**Heathland Wind Farm**  
**Environmental Statement Addendum**

September 2016

**Proposed Design Changes -**  
**Revised Visualisations and Landscape Addendum**

Ver: 3.0      A3      Figure : 1.2  
Revised Aug 2016

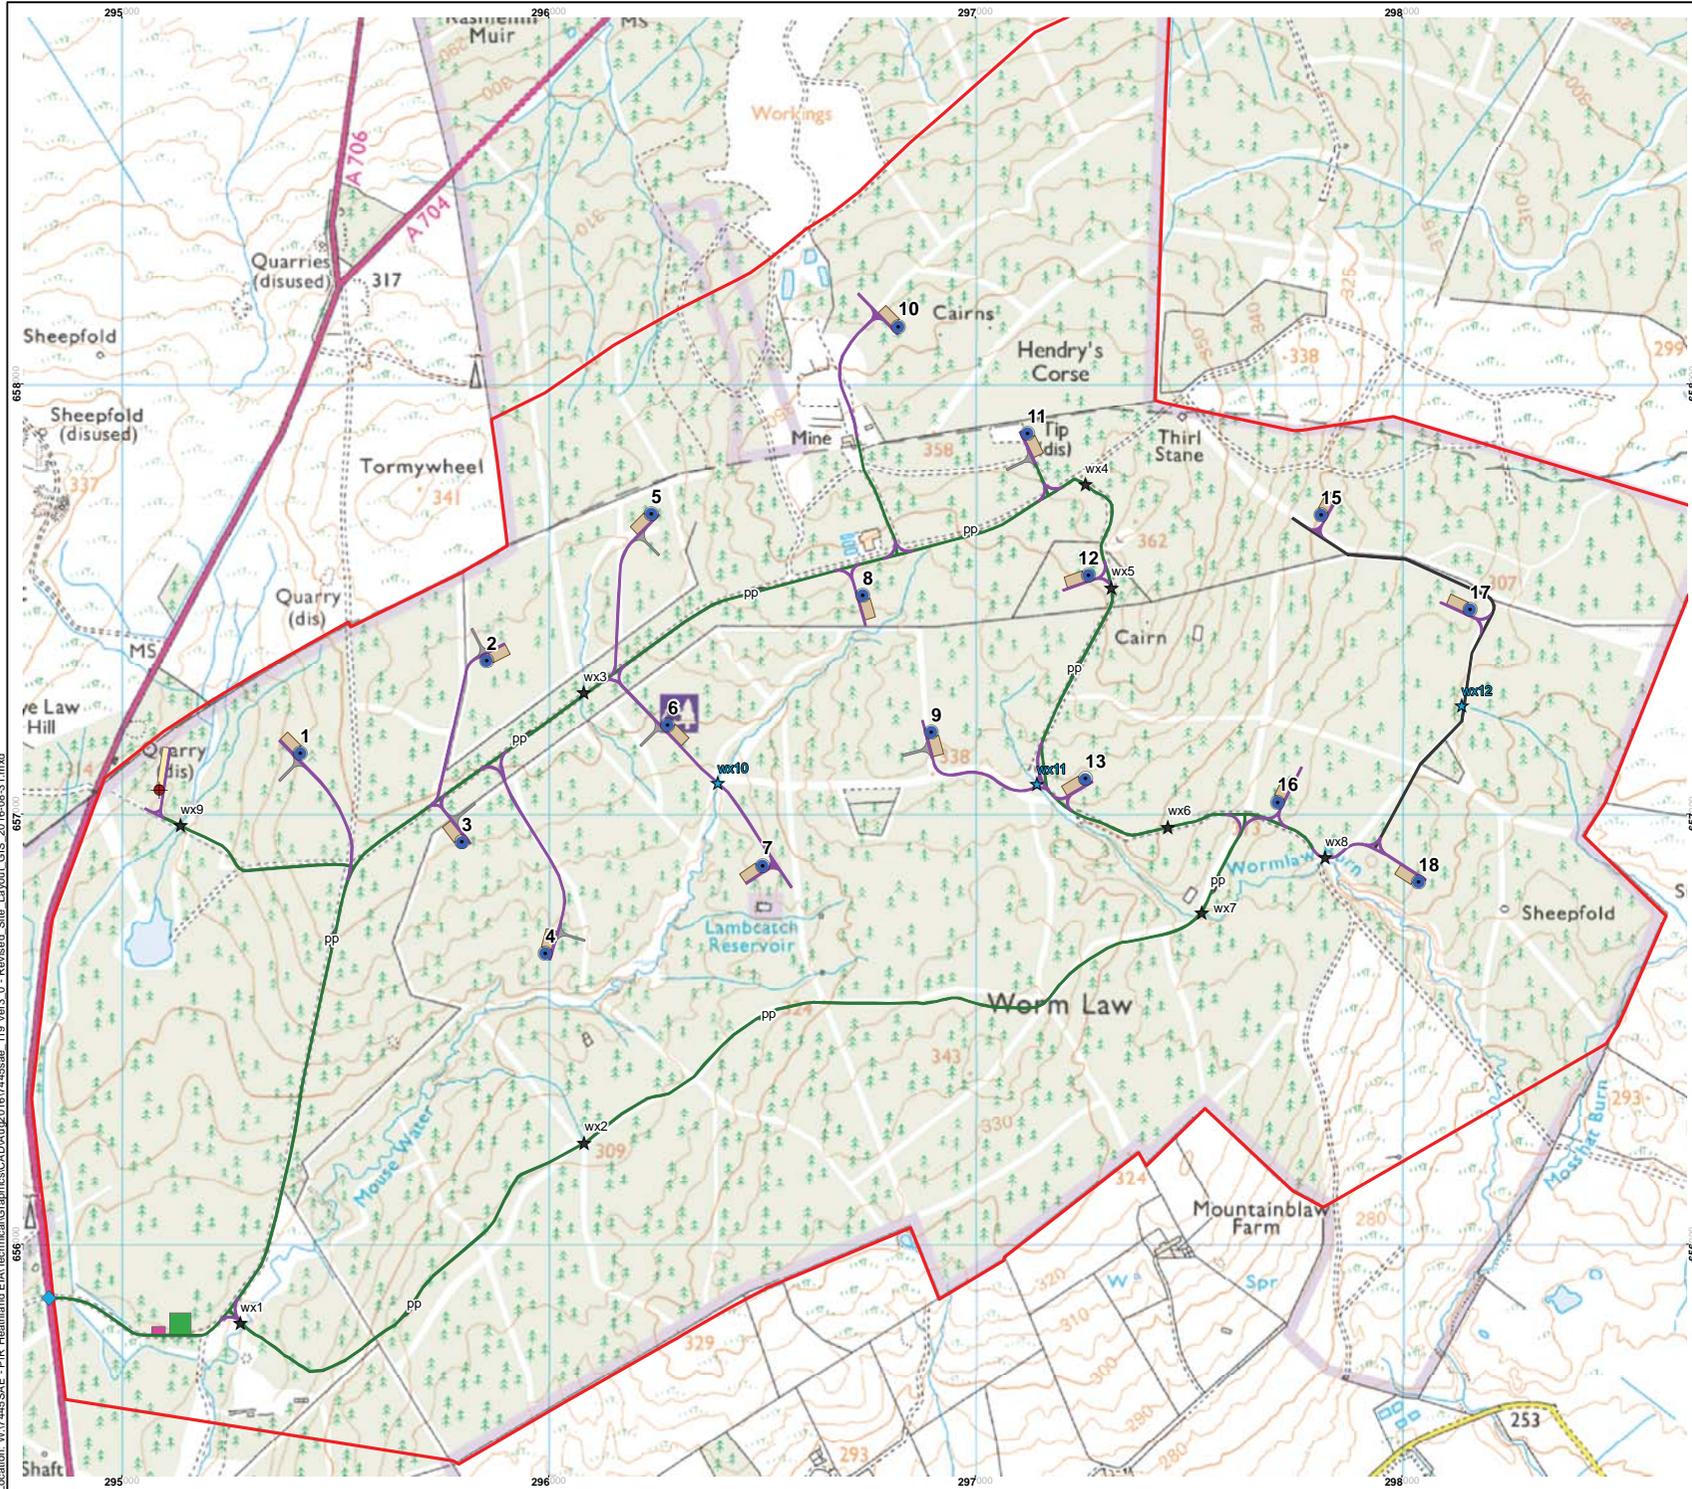
- Three turbines have been deleted from the scheme (T14, T19 and T20).
  - The on-site access track spurs serving the three deleted turbines have been removed, along with the turning heads for T19 and T20.

- The crane hardstanding areas serving the three deleted turbines have been removed.

- 1.2.4 The amended site layout is shown on Figure 1.2 of this Addendum. To avoid any potential confusion between the original and amended site layout the original turbine numbers have been retained.
